**REMARKS**

Claims 1, 2, 5, 7-10, 12-17, 19-23, 27, and 28 stand rejected under 35 U.S.C. § 102(b) as being anticipated by U.S. Patent No. 3,147,822 to Watts. Claims 3 and 6 stand rejected under 35 U.S.C. § 103(a) for obviousness over the Watts patent. Claims 4, 11, and 18 stand rejected under 35 U.S.C. § 103(a) for obviousness over the Watts patent in view of U.S. Patent No. 2,489,182 to Huck. In response, Applicants have amended claims 1, 9, 14, 15, 17, and 23. In view of these amendments and the following remarks, Applicants traverse the rejections.

FIG. 2

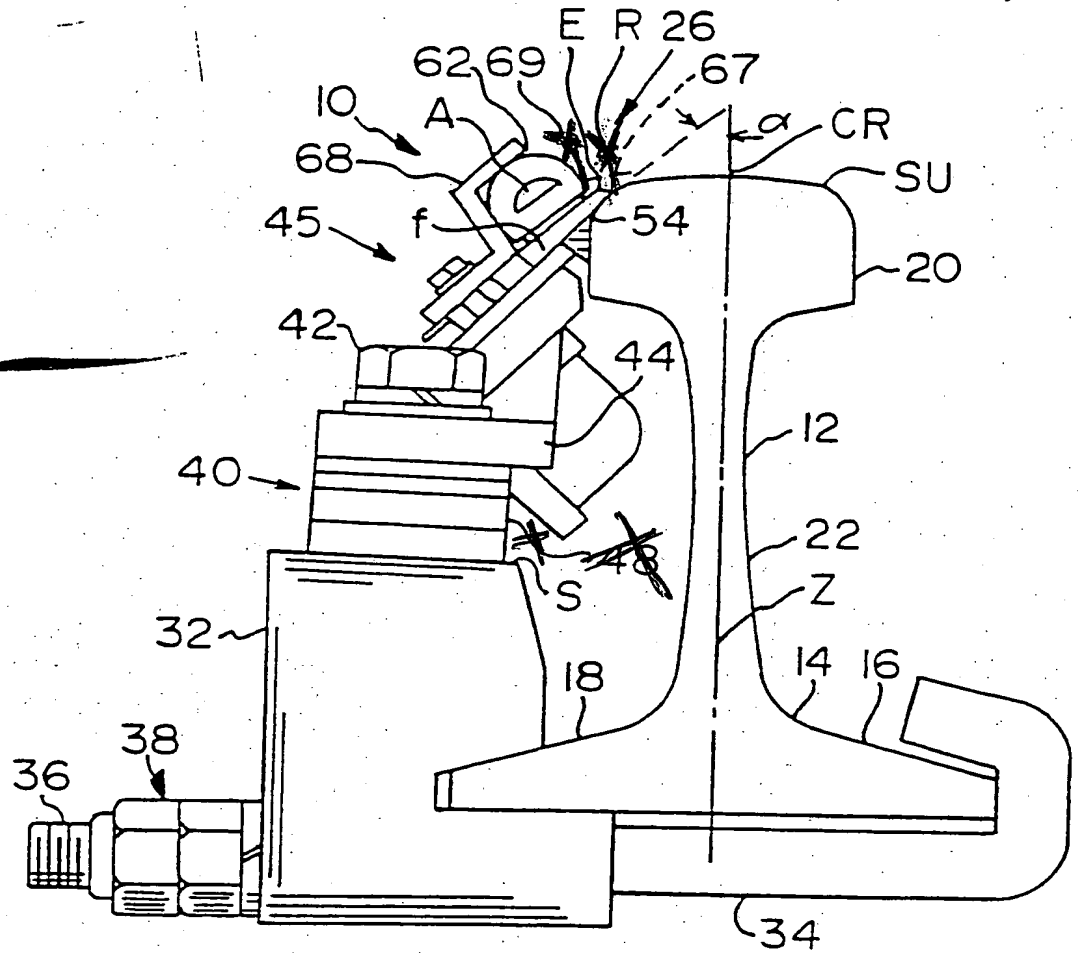
The drawings stand objected to for various informalities. Specifically, two reference numerals 48 have been included in the drawings related to the manifold and spacers. In response, the reference character 48 has been eliminated. The spacers have been identified as reference character 40. Likewise, the specification has been amended to identify the spacers as reference character 40. Figs. 2 and 5 have been amended to correct lead lines.

*Proposed change in  
 112 and yellow highlight*

FIG. 5

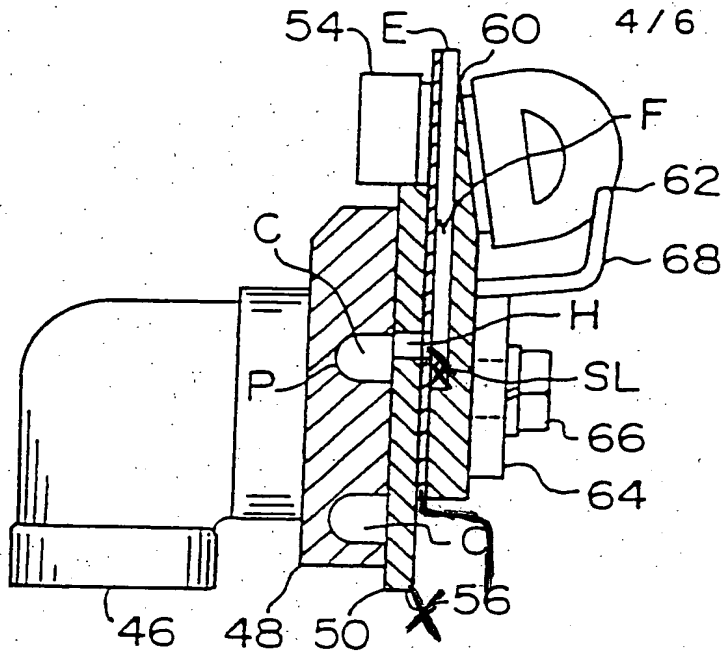
*Proposed change  
 in red and yellow highlight*
